Architectural Review Board

Meeting Minutes

November 13, 2017

ARB-57-2017 Certificate of Appropriateness

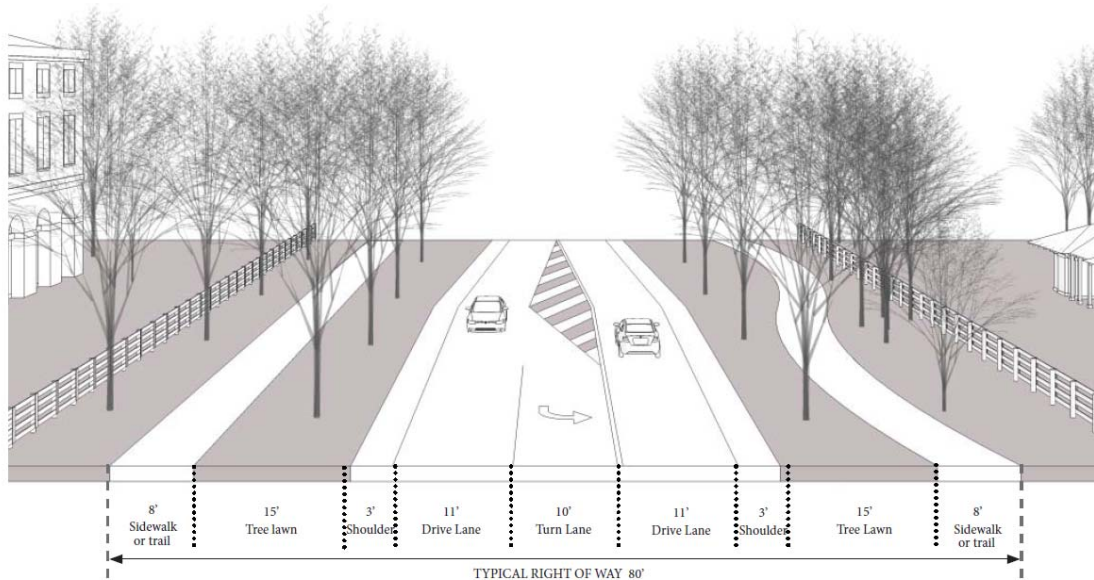
- Per DGR Section 8(III)(3) traditional practice states that the entrances to civic and institutional buildings shall be oriented toward primary streets and roads and shall be of a distinctive character that makes them easy to locate. Entrances

shall be scaled and detailed to match the scale and detail of interior public spaces. As proposed an entrance and windows will be located on the main façade that fronts onto Dublin-Granville Road. The brick detailing and stone water table adds to the distinctive character of the church, making it easy to locate.
